SEAGRAVE FIRE APPARATUS DIVISION

PRODUCT SUPPORT BULLETIN

SUBJECT: LEVER STYLE INTERIOR CAB DOOR LATCH HANDLES

No. 04-97 DATE August 25, 1997

LEVER HANDLE DOOR OPERATION ILLUSTRATION

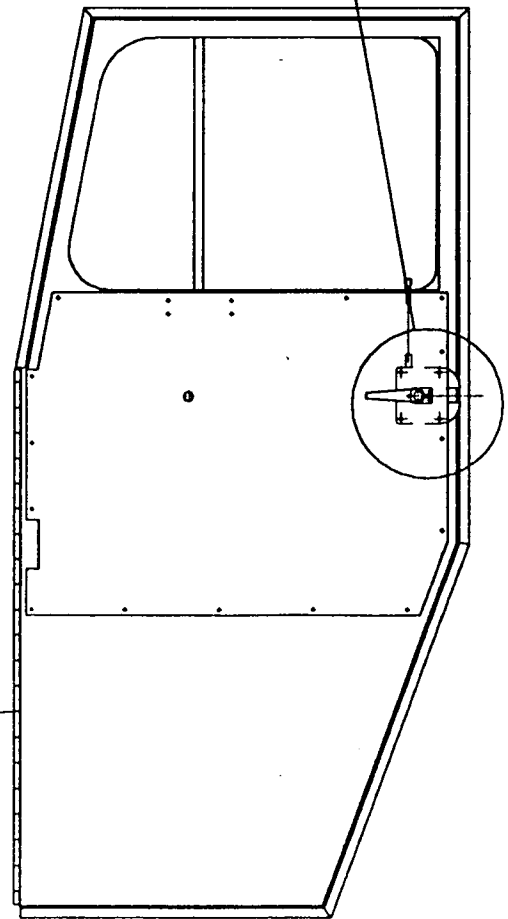
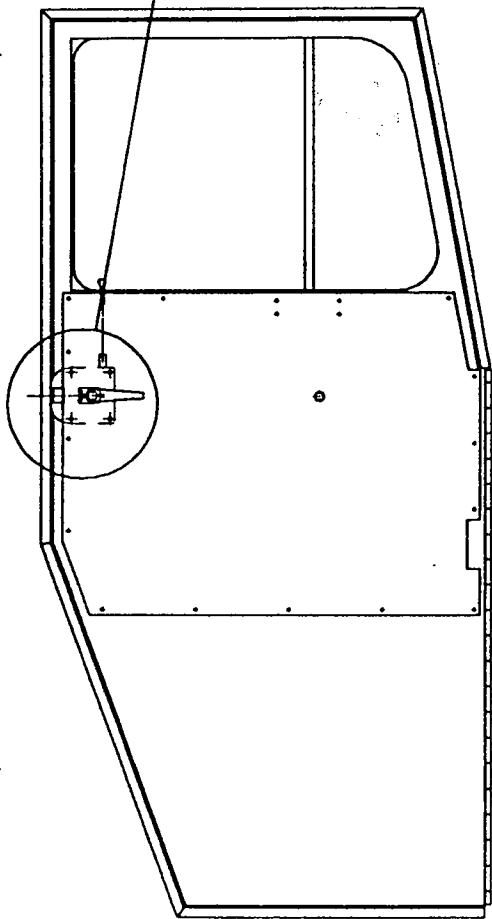
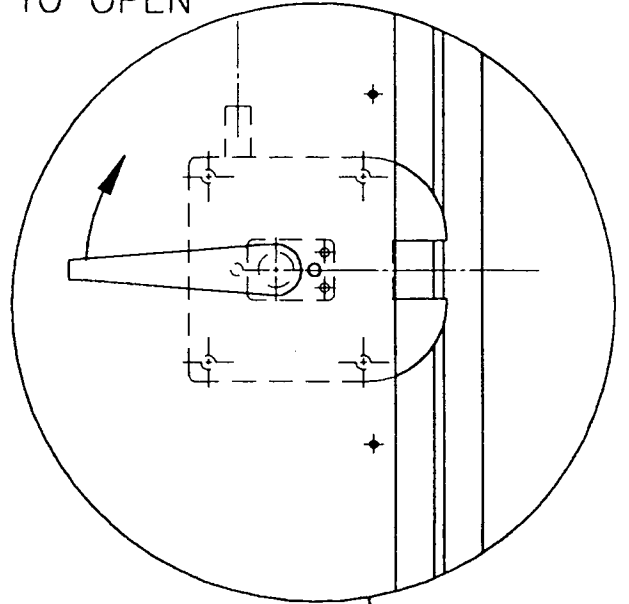
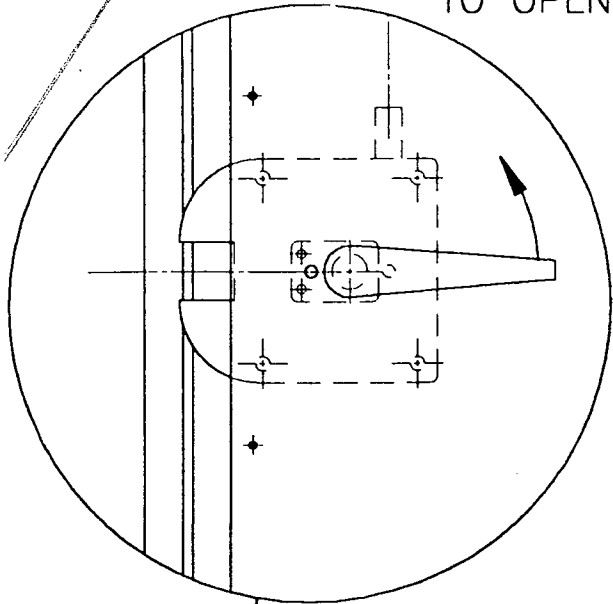
Installation: The replacement handles must only be mounted in the pull-up position using only the fiber gasket and one half inch long screws furnished with the handle.

The "pull-up" to open directional mechanism is located in the handle mounting plate. Do not substitute any handle that will allow opening of the door in any motion other than "pulling up" on the handle.

INTERIOR "L" HANDLE - L.H.
90° ROTATION
P1060400

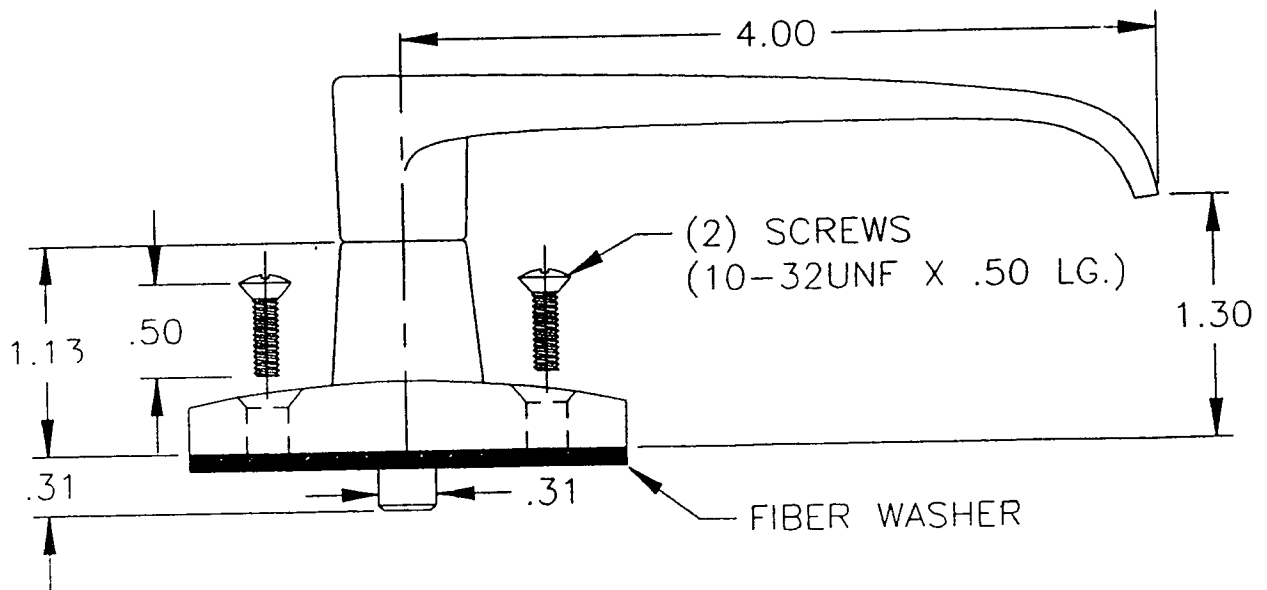
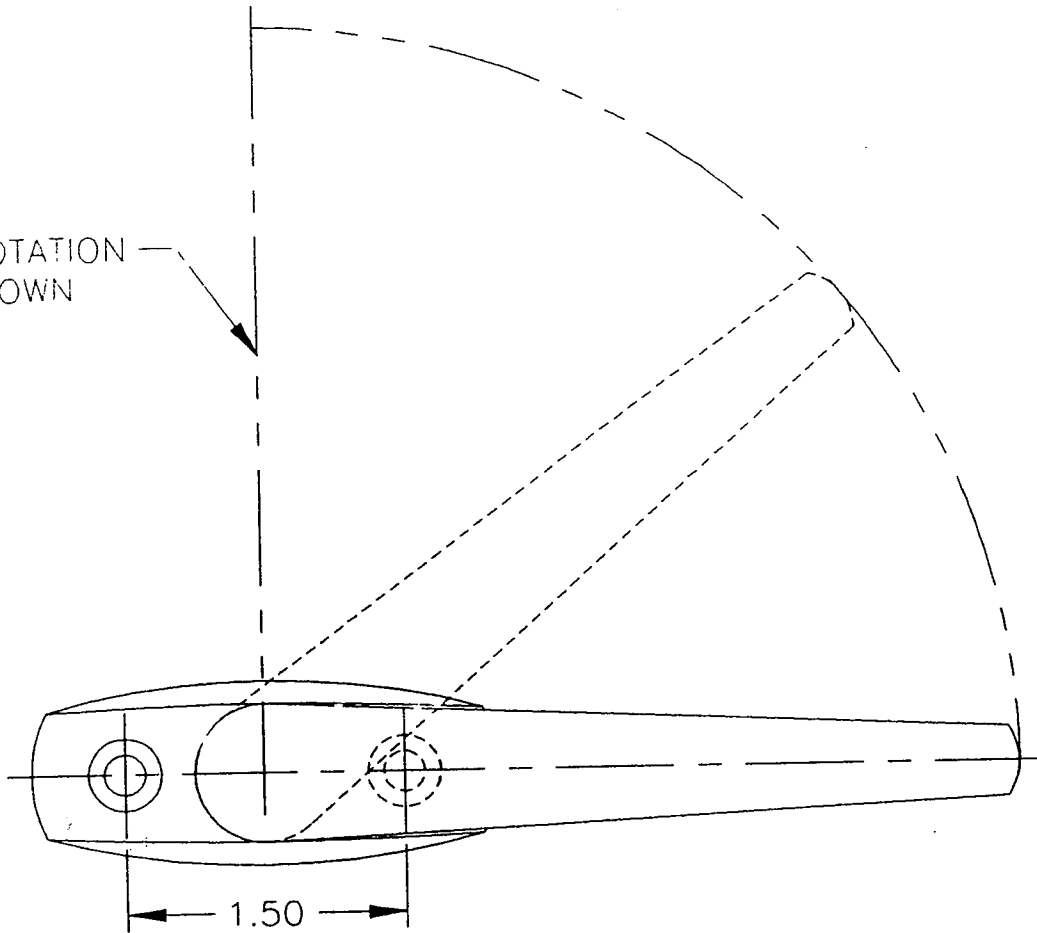
This handle with the 5/16" black spacer used on both the right and left hand door latch assembly has been discontinued by the manufacturer and replaced with a handle having a thicker attachment plate that is limited to 90 degrees of rotation when not fastened to the latch. This new handle requires that a left hand handle be installed only on the left hand door latch and a right hand handle for the right hand door latch in order for the door to be opened with a pull up motion from a horizontal position. When ordering and/or replacing the original handle, the specific door side must be stated, and replacement inventory must be clearly marked for the correct door.

90° ROTATION
AS SHOWN

The left hand door is any door to the left of the driver when he is seated in the driver's position and the right hand door is any door to the right of the driver when he is seated in the driver's position. Order and install part number P1060300 on right hand doors only. Order and install part number P1060400 on left hand doors only.
